TO: Township of West Orange Planning Board

FROM: Malvika Apte, PP, AICP, Planning Board Planner 
Langley Oudemans, Associate Planner

RE: PB Application 25-11
Planning Review # 2
525 Northfield Avenue
Block 159.04, Lot 1.01
Preliminary & Final Major Site Plan Approval and "C" Variances Approval

DATE: April 8, 2026

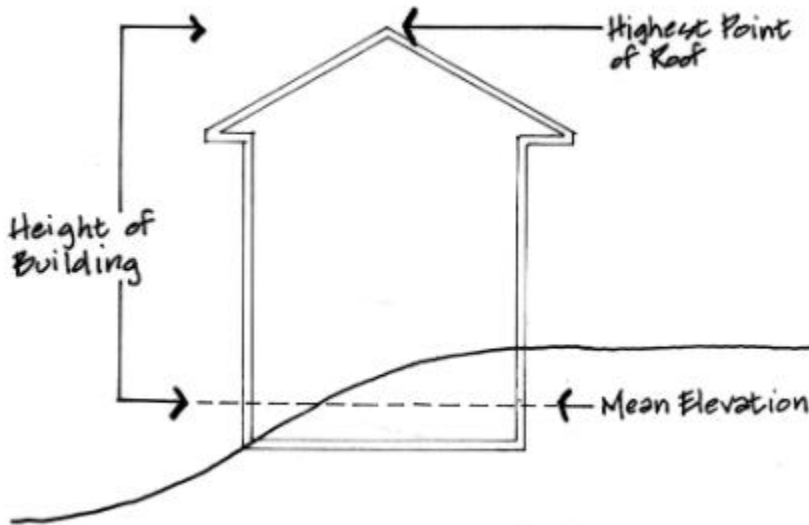
*The building height as measured from the average grade of the roof has been provided; however, the height of roof features has not been provided and compliance with height limits cannot be determined.

Applicant to provide the height of roof features including parapets, stair and elevator bulkheads, and overall height of the building in order to confirm compliance.

The proposed building is 4-stories/ 38.5 ft, measured to the highest point of roof. Per the Land Use Ordinance §25-4, building height is depicted per the figure below taken from mean elevation to the highest point of the roof. We recommend a detailed calculation of the height of the building be provided based on this graphic.

Additionally, as stated above, **the applicant should provide the height of building appurtenances such as parapet, stair bulkhead and other mechanical features to determine they do not exceed 10 feet in height.**
